# VILLAGE OF WESTMONT Board of Trustees Memorandum January 13, 2022

#### **Item for Board of Trustees Consideration:**

Board to consider an ordinance approving requests from CD ZA, Inc. (d/b/a Mrs. T's Pizza and Pub), and 2 W. Naperville Road, LLC, regarding the property located at 2 West Naperville Road, for the following:

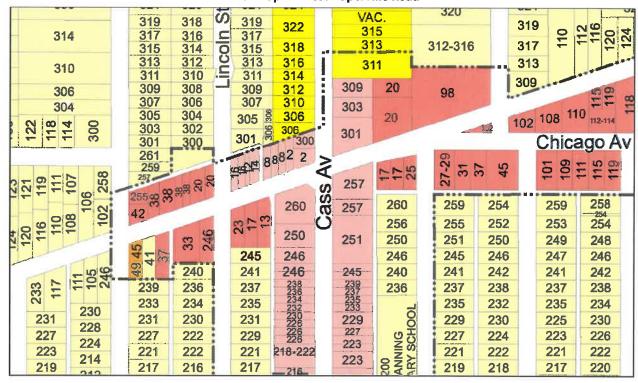
- 1) That revisions be made to the north elevation to be accurate; and
- 2) That a photometric plan be submitted as the parking lot does not have any lighting proposed.

A revised north elevation has been submitted and accurately depicts mechanical equipment that had been omitted, and removed two faux windows initially shown on the first floor.
